National Committee on Uniform Traffic Control Devices

TECHNICAL COMMITTEE RECOMMENDATION

TOPIC: Proposed Shared Lane Marking
Part 9 of the MUTCD

Diagram from San Francisco Shared Lane Marking study

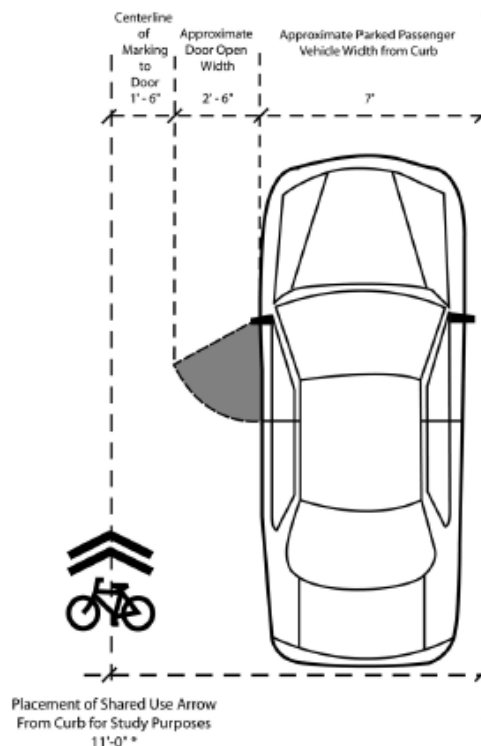
The results showed significant improvements to bicyclists' and motorists' positioning in the roadway, and identified the bike-with-chevron marking as most effective. These results have since provided guidance to the California Department of Transportation (Caltrans) to adopt the Shared Lane Marking in the California Supplement to the MUTCD.

- Improves positioning of the bicyclist and motorist
 - Increases the distance between bicyclists and parked cars (by 8 inches in the SF study)
 - Increases the distance between overtaking motorists and bicyclists (by 2 feet in the SF study)
- Improves bicyclist behavior
 - Reduces wrong-way bicycling, a major cause of collisions (by 80% in the SF study)
- Reminds motorists of likely bicyclist presence
 - When surveyed, motorists claimed they did not notice the marking; however, the data indicates that their position on the roadway was adjusted to better accommodate bicyclists.
